AGENDA

**Regular Planning Commission Meeting
Thursday, January 25, 2024 6:00 PM
300 Wall Street, Fountain Inn, South Carolina**

Re: Woodside Village Preliminary PD Response
D&F Job Number: 4217200

RE: PZ-2024-01 Woodside Village Planned Development

PRELIMINARY DEVELOPMENT PLAN

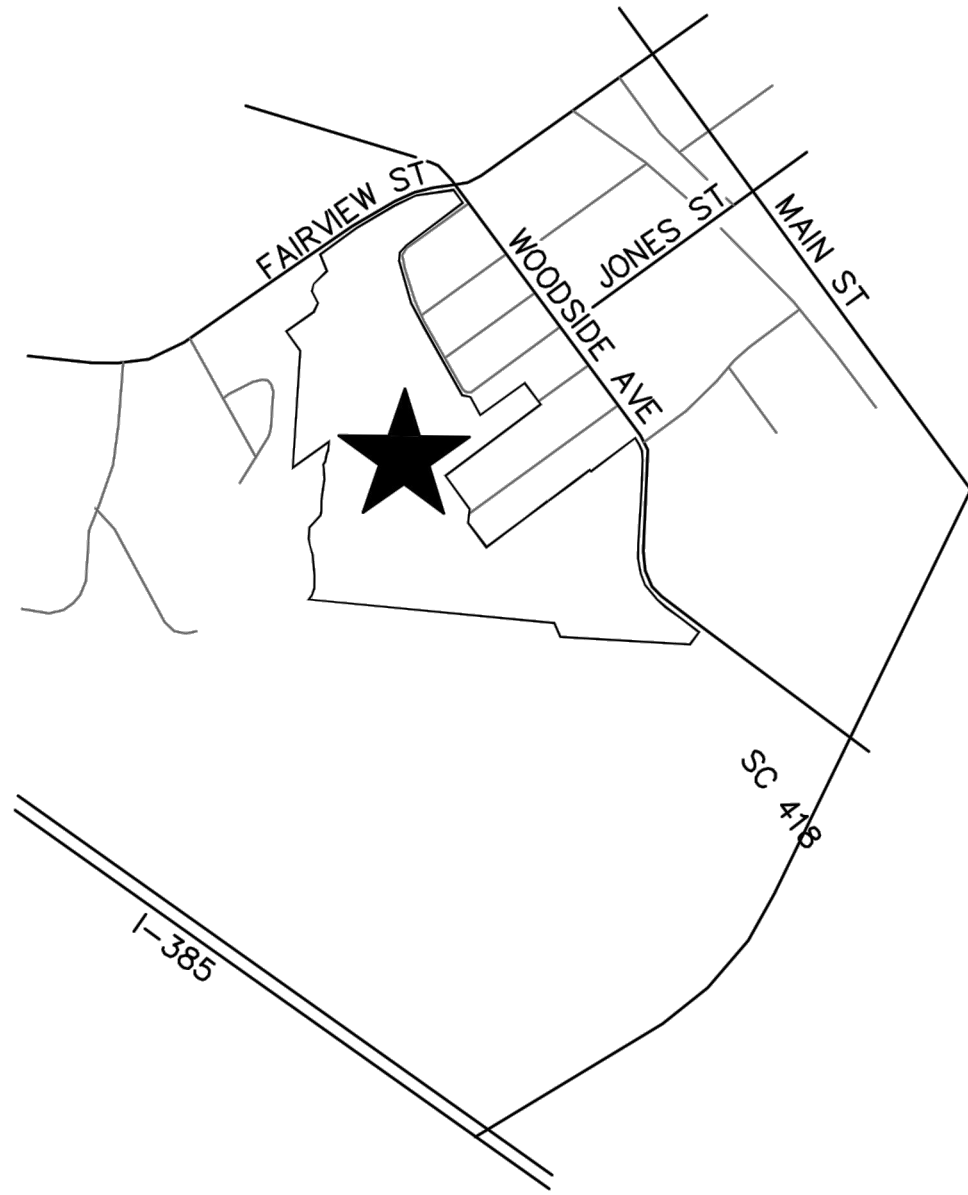
We are writing to communicate the changes shown in the recently submitted preliminary PD package for Woodside Village. This site had previously been approved in a PD submittal but 2 layout issues have caused revisions and the need to resubmit.

Originally, a proposed entrance was shown which connected the multi-family (Zone 2) at Fairview Street. The SCDOT has since told us that connection to Fairview Street can only be used as an emergency entrance, and they will not allow it as a major entrance so close to Diamond Tip Blvd. That connection, which was originally a major entrance point, will now be shown as an emergency entrance.

Second, the internal phase line that divides the apartments (zone 2) and the residential (zone 3) originally has been altered. (Zone 2) now contains the mill apartments and a section of stacked flats and an above grade stormwater pond. (Zone 2) has been expanded to include the area of previous zone 3 and no longer contains single family homes. (Zone 3) has been shifted and is now designated for single family homes only for future development.

The applicant is proposing the realignment of zone 2 and zone 3 of the Woodside Village Planned Development. Zone 2 has been expanded to include the previous area designated as zone 3. Zone 2 will consist of the Mill Apartments, a section of stacked flats, and an above grade stormwater pond. Zone 3 has been shifted and is designated for future development of single-family homes. Zone 1 is designated for future development of office/commercial space with residential units. Future developments in zones 1 and 3 will require a major change to this approval. Details and specifications for these zones will be addressed as part of the major change request.

The site is accessed from one location on Diamond Tip Blvd. Previous approvals included an additional access point on Fairview Street, but that has been removed per SCDOT. That access will be designated for emergency access only. Additionally, 236 parking spaces are included in Zone 2. This does not meet the requirements of the Fountain Inn Zoning Ordinance.

Based on these reasons, staff recommends approval of the requested Major Change to the Woodside Village Planned Development, with the following conditions:

1. Emergency access must be provided along Fairview Street.
2. A Final Development Plan must be reviewed and approved prior to the issuance of any permits.
